Access Compliance Report Public Rights-of-Way (Curb Ramps)

Intersection ID: 31268Main Street:MALLARD_OAKS_DRCross Street: JOHN_ADAMS_RDLocation:WADA ID: 52AC6687CBA0Ramp Type:PerpInitial Pass/Fail:FailOverall Compliance: NoSeverity Score:26.25

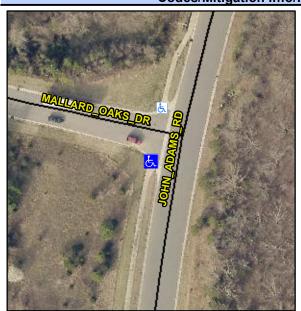
PROW/ADA:
R304.2.2, R304.5.3

Field Measurements/Component Compliance					
Compliance Description		Data	Comp	oliance Description	Data
N/A	Ramp Length (in)	71.0	No	Ramp Slope (%)	14.4
Yes	Ramp Width (in)	48.0	No	Ramp XSlope (%)	3.6
N/A	Flare Type LT	N/A	N/A	Flare Type RT	N/A
N/A	Flare Slope LT (%)	N/A	N/A	Flare Slope RT (%)	N/A
N/A	Flare Traversable LT?	N/A	N/A	Flare Traversable RT?	N/A
N/A	Landing Length (in)	N/A	N/A	DWS Provided?	N/A
N/A	Landing Width (in)	N/A	N/A	DWS Contrast?	N/A
N/A	Landing Slope (%)	N/A	N/A	DWS Length (in)	N/A
N/A	Landing X Slope (%)	N/A	N/A	DWS Full Width?	N/A
N/A	Landing Curb? (Y/N)	N/A	N/A	DWS Offset (in)	N/A
N/A	Shared Landing?	N/A			
N/A	Gutter Ponding?	N/A	N/A	Gutter Slope (%)	N/A
N/A	Gutter Lip Ht (in)	N/A	N/A	Gutter X Slope (%)	N/A
N/A	Painted X Walk1?	No	N/A	Painted X Walk2?	N/A
	X Walk 1 Direction	To NE		X Walk 2 Direction	N/A
N/A	X Walk 1 Width (in)	N/A	N/A	X Walk 2 Width (in)	N/A
	X Walk 1 Slope (%)	4.0		X Walk 2 Slope (%)	N/A

Possible Solutions:
Remove & Replace Entire Ramp.
